Access Compliance Report

Public Rights-of-Way

Intersection ID: 11088	Main Street: ASHBY_ST	Cross Street: N_TRYON_ST	Location: N
ADA ID: 0A0536773C51	Ramp Type: PerpDiag	Initial Pass/Fail: Fail	Overall Compliance: No
Severity Score: 33.75			
Codes/Mitigation Info/Possible Solution		Field Measurements/Component Compliance

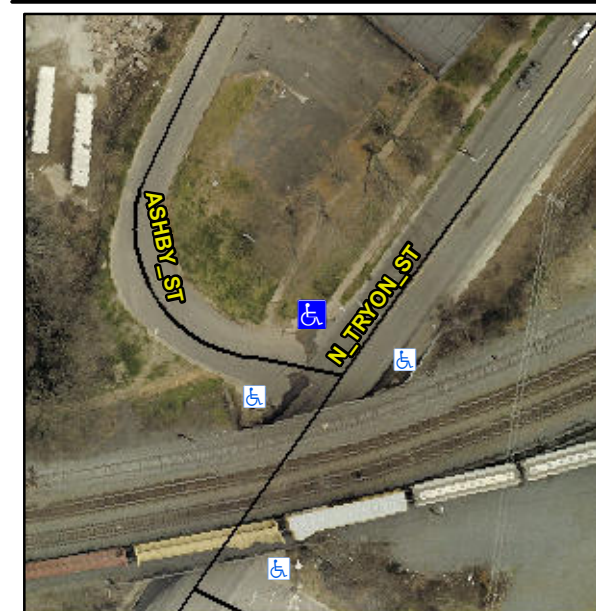
Not Found, R304.5.1, R304.2.2

Compliance	Description	Data	Compliance	Description	Data
N/A	Ramp Length (in)	59.0	No	Ramp Slope (%)	15.3
No	Ramp Width (in)	43.0	Yes	Ramp XSlope (%)	1.4
N/A	Flare Type LT	N/A	N/A	Flare Type RT	N/A
N/A	Flare Slope LT (%)	N/A	N/A	Flare Slope RT (%)	N/A
N/A	Flare Traversable LT?	N/A	N/A	Flare Traversable RT?	N/A
N/A	Landing Length (in)	N/A	N/A	DWS Provided?	N/A
N/A	Landing Width (in)	N/A	N/A	DWS Contrast?	N/A
N/A	Landing Slope (%)	N/A	N/A	DWS Length (in)	N/A
N/A	Landing X Slope (%)	N/A	N/A	DWS Full Width?	N/A
N/A	Landing Curb? (Y/N)	N/A	N/A	DWS Offset (in)	N/A
N/A	Shared Landing?	N/A			
N/A	Gutter Ponding?	Yes	N/A	Gutter Slope (%)	N/A
N/A	Gutter Lip Ht (in)	N/A	N/A	Gutter X Slope (%)	N/A
N/A	Painted X Walk1?	No	N/A	Painted X Walk2?	No
	X Walk 1 Direction	To SW		X Walk 2 Direction	To SE
N/A	X Walk 1 Width (in)	N/A	N/A	X Walk 2 Width (in)	N/A
	X Walk 1 Slope (%)	0.1		X Walk 2 Slope (%)	0.9
	X Walk 1 X Slope (%)	0.5		X Walk 2 X Slope (%)	0.9

Remove & Replace Curb Ramp With Two New Directional Ramps or Equivalent.
